Jenny Chu
Planner
Department of Planning, Industry and Environment

National Trust submission relating to Fort Street Public School

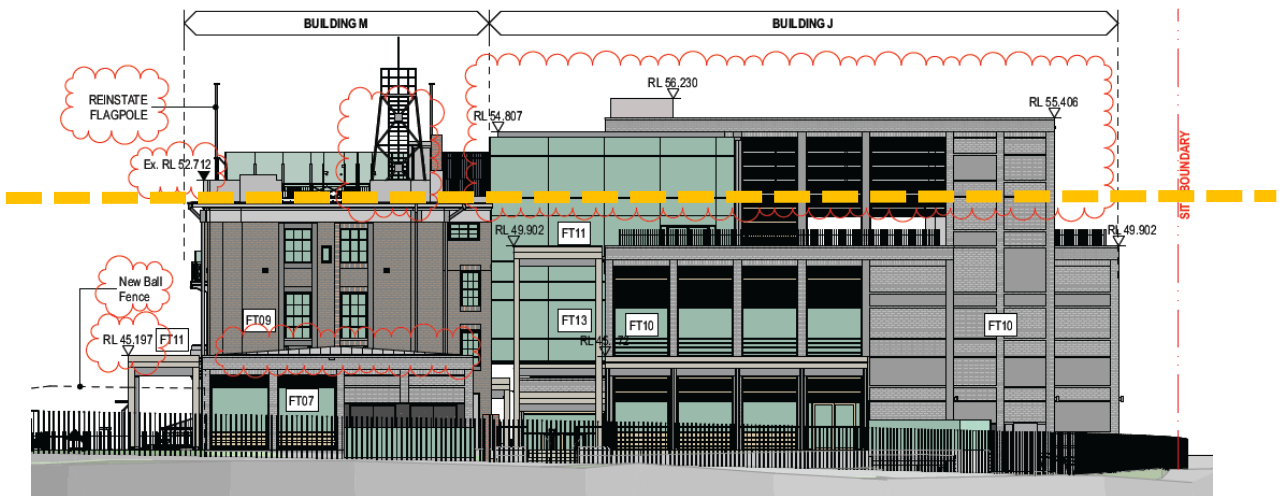
The new design means that a large, four-storey fire escape stair will now loom over one of Sydney’s oldest public buildings (the National Trust Centre, housed within the remaining sections of the 1815 Military Hospital and 1840 National School) and be the immediate view from the main entry and exit door to the S.H. Ervin Gallery, housed within the 1856 Fort Street School building.

The approved design (left) and the “modified” design (right). Given the sensitive location, and the relatively small scale of the works under discussion and their impact on adjacent heritage buildings, this must not be considered a modification as per the definition under Section 4.55(2), which states that works must be “substantially the same” for which consent was originally granted. (Source: FJMT Architectural Design Statement, pp.29-30)
